Application Ref: NP/16/0633/FUL

Case Officer	Caroline Bowen		
Applicant	Mr D Chambers		
Agent	Mr C Henderson, LS Design (Lindum Group Ltd)		
Proposal	Refurbishment of existing cattle barn to form garden room, study and WC (Retrospective).		
Site Location	1, Square Farm, Marloes, Haverfordwest, Pembrokeshire, SA62 3BD		
Grid Ref	SM79140851		
Date Valid	30-Nov-2016	Target Date	08-Feb-2017

Proposed Floor Plan

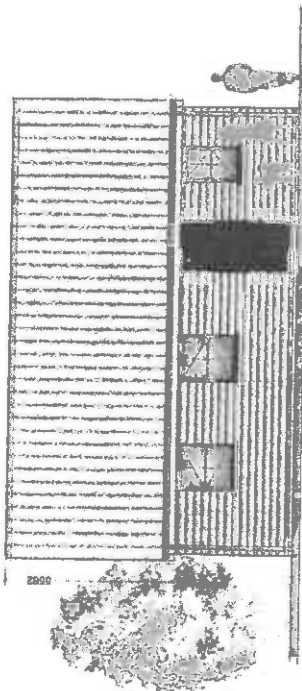
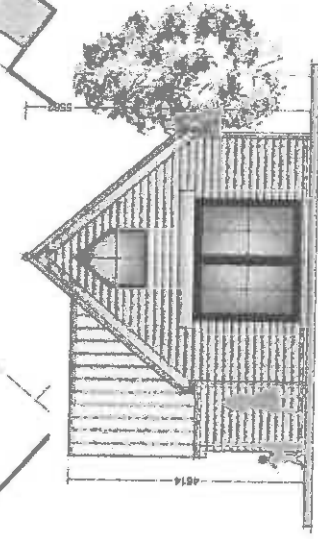
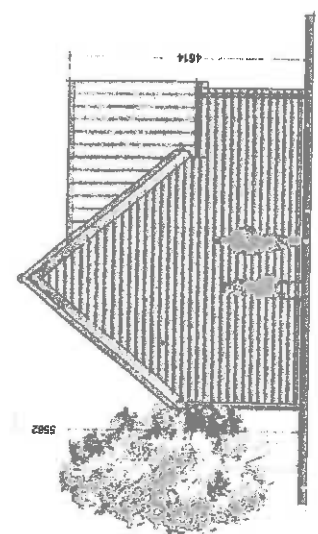
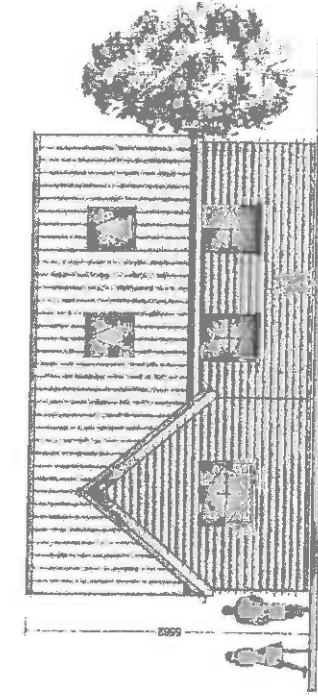
To back up this objection further still, my Community Council has looked at the plans for the original building, the plans from application NP/12/0179 and the plans from this application NP/16/0633/FUL and have calculated the square meterage of each...
...the plans now submitted show that the building, as constructed is 45% greater in volume than the plans that were passed...

With the scale of this building as it now stands it is certainly having an impact on neighbouring properties and yet in the 'Design and Access Statement' under the heading, Scale, it quite clearly states ' The proposals are limited to single storey so as not to impact in any way on the neighbouring properties'.

Following investigation by the Authority's enforcement officers, this planning application has been submitted in order to attempt to regularise the development, which has not been built in accordance with the 2012 permission. This relates to the height of the building to ridge, the depth of the structure, and to the insertion of 2 roof lights to the rear elevation of the building.

The dimensions of the building are, therefore, 8.76 metres in length, 6.15 metres in depth and 5.56 metres in height to the ridge. This is an increase in width of the rear wing by 1.0 metres, and an increase in the overall height by 0.93 metres.

In respect of the proposed increase in volume, the key issue is to consider whether the increase in footprint and height has resulted in a building that is markedly different from that originally approved. The increase in width of 1 metre to the rear 'wing' is sited away from any neighbouring property, and the footprint remains well within the curtilage of the main dwelling. This, therefore, is not considered to result in any visual or physical harm to existing properties. In respect of the increase in height, the building is at a sufficient distance from neighbours to ensure that no overlooking or overshadowing would result. Officers appreciate that concern is raised that the structure is taller, however, this is not considered harmful to the external appearance of the structure, and would not result in material harm to the surrounding properties.
